SEWAGE DISPOSAL SYSTEM

MARYLAND STATE DEPARTMENT OF HEALTH

SUBDIVISION _____ ROAD 1029 St. Michael's Road LOT _____

RE: Shed Addition Information Request
1029 St. Michael's Road
Zoned: RC - Rural Conservation
Tax Map 7, Block 3
Election District 4, .526 Acres

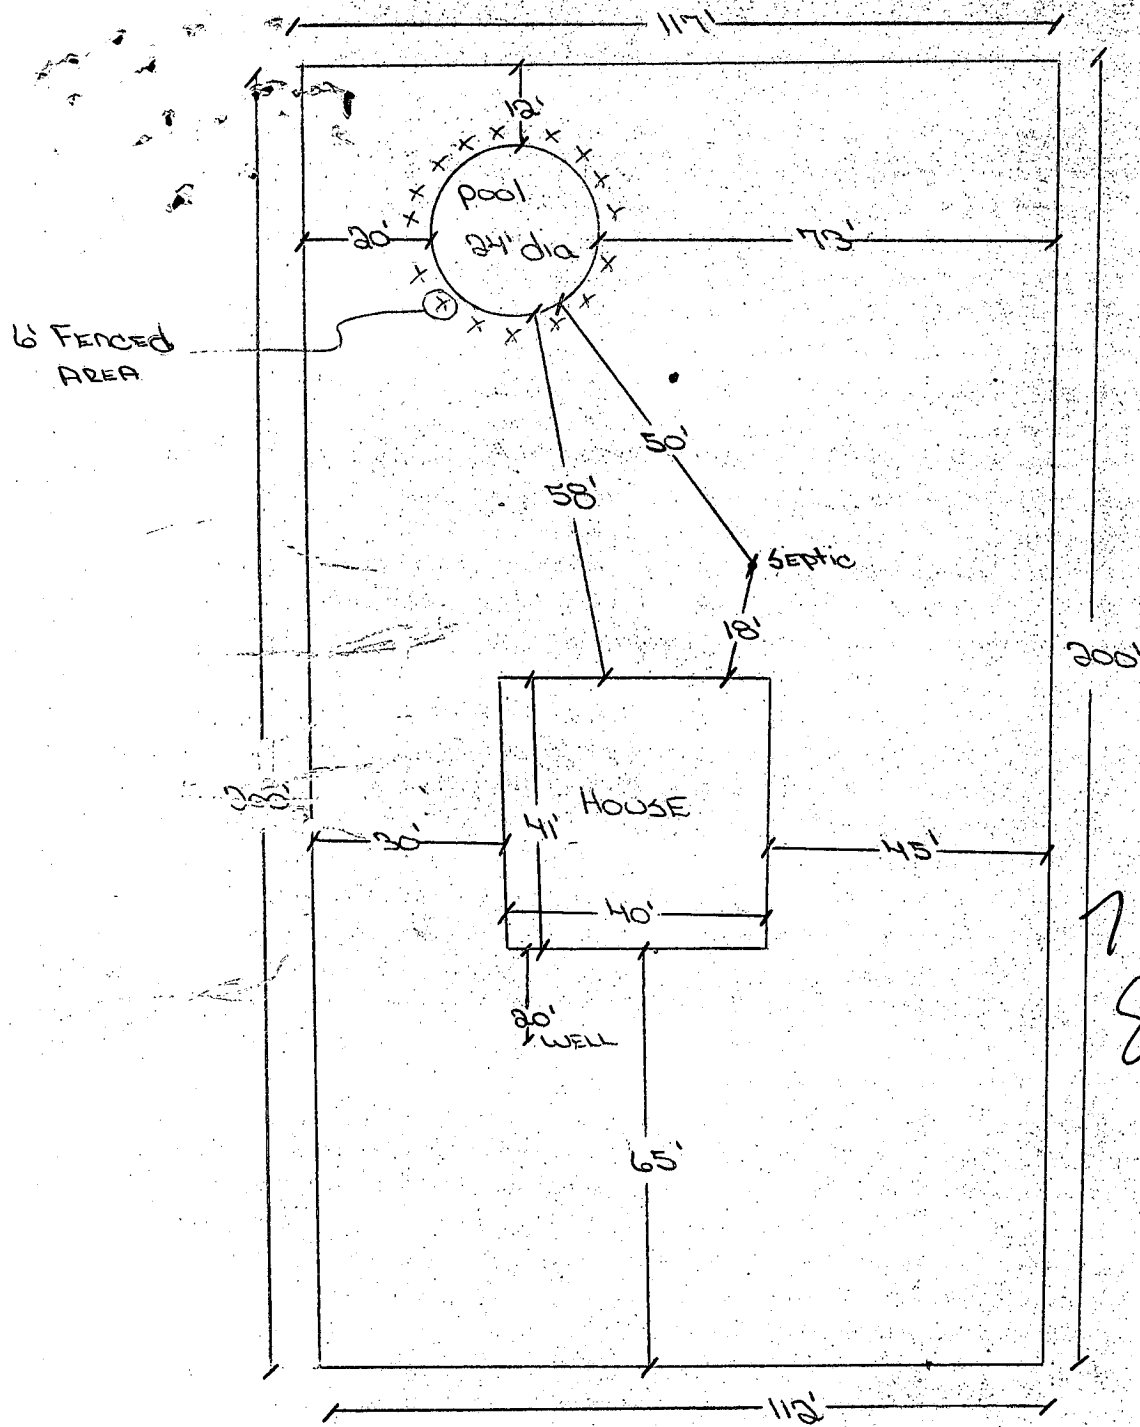
REMARKS: 4/23/81 { NOLE ① DRYWELL 15X15' } { 4' TO 10' } NEED CLEANOUTS TO GRADE ON ALL SEWAGE DISPOSAL UNITS. PM 4/27/81 OK TO COVER FROM SEPTIC TANK TO DRYWELL ①, AND FROM DRYWELL ① TO DRYWELL ②. ONLY PARTIAL; 4/28/81 SYSTEM COMPLETE. C.B.S.

DATE SYSTEM APPROVED 4/28/81 INSPECTOR C.B. Streaker

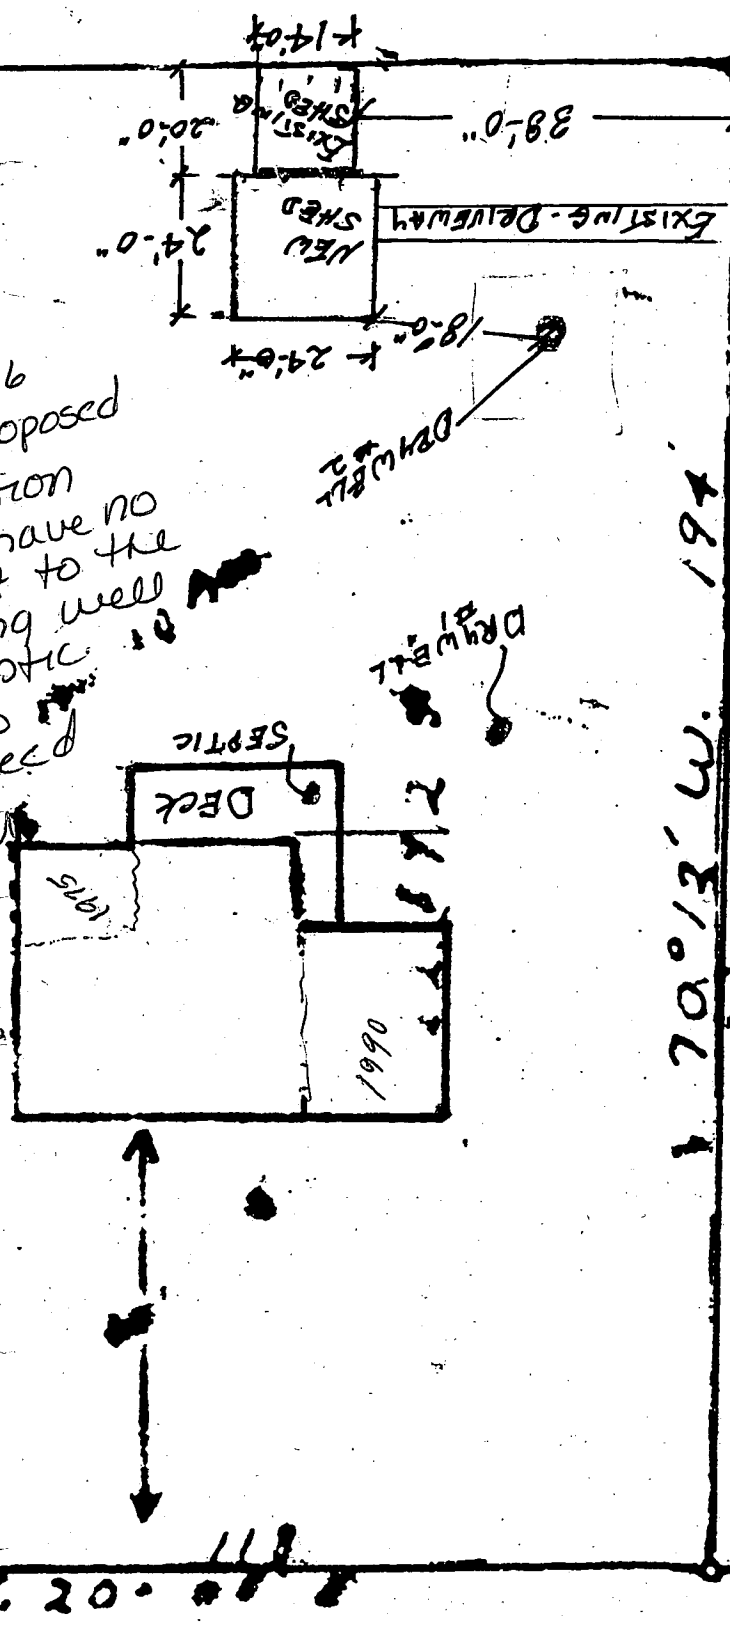
10/31/96
 The proposed addition will have no impact to the existing well or septic.
 OK to proceed
 MW
